Docket Item # 1  
BAR CASE # 2011-0326

BAR Meeting  
December 7, 2011

**ISSUE:** Alterations to previously approved plans  
**APPLICANT:** Jay & Judith Turim by M. Catherine Puskar  
**LOCATION:** 616 South Royal Street  
**ZONE:** RM/Townhouse Zone

Figure 1: Drawing showing 2003 approved and existing/proposed fence height. The background elevation drawing is from the 2008 alterations.

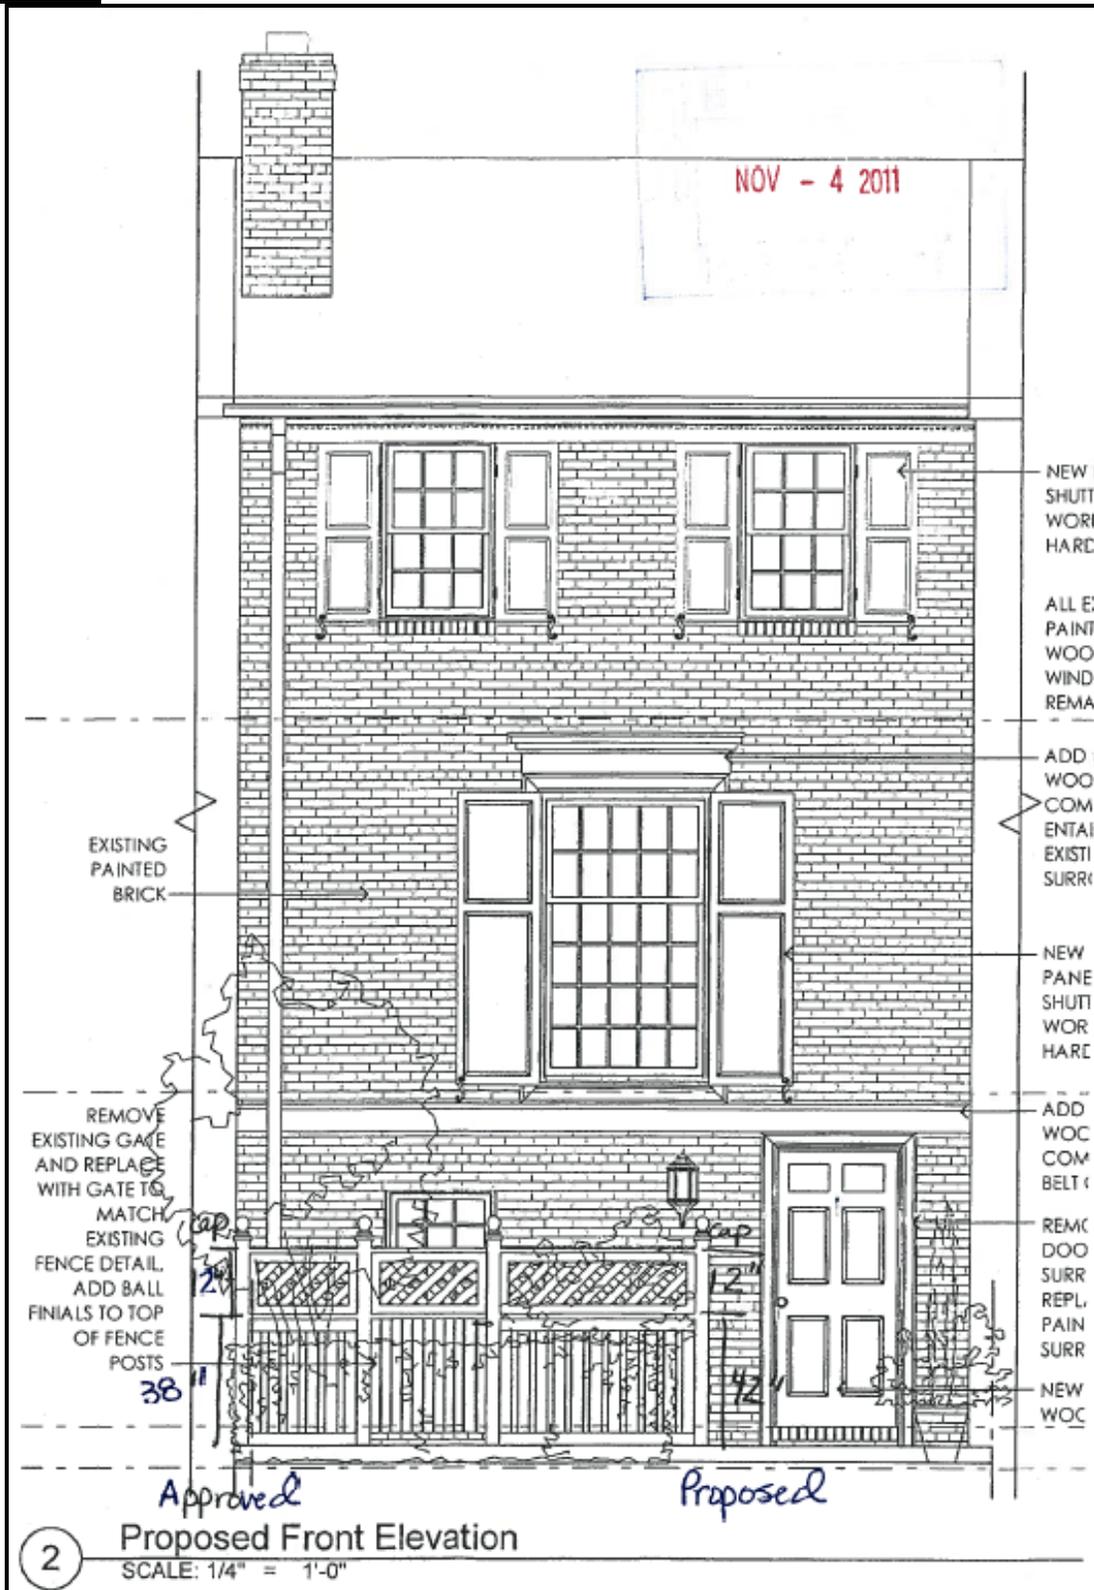
The applicant is requesting approval of an after-the-fact 4 inch height increase to a Board-approved 50” tall HVAC screen at 616 South Royal Street. The HVAC enclosure measures approximately 11.5 feet wide by 54 inches high and is located to the north of the front door. No new construction is associated with the requested height increase, as the HVAC screening was constructed in 2003 at 54 inches.

As a result of a recent complaint, Staff and the applicant were made aware of a 4 inch height discrepancy between the Board approved enclosure (50 inches high) and what was actually installed (54 inches high). The 2008 BAR approval for minor modifications to the screening did not include a request for the additional 4 inch height because, at that time, neither the applicant, nor Staff, realized that the fence was not in compliance with prior approvals. The applicant surmises that the contractors installed a 42 inch high fence in compliance with the first approval, and subsequently installed a 12 inch lattice in compliance with the later 2003 approval.

Staff has no objection to the 4 inch height increase on the HVAC screening. The Board has approved the HVAC screening enclosure on more than one occasion and the additional height, when originally constructed in 2003, was consistent with the original design intent. If the height increase was obvious, Staff would have made the Board aware of the inconsistency when it was included in materials that were submitted to the Board during the alterations in 2008. Therefore, Staff recommends approval of the application as submitted.

**STAFF RECOMMENDATION:** Staff recommends approval of the application as submitted.
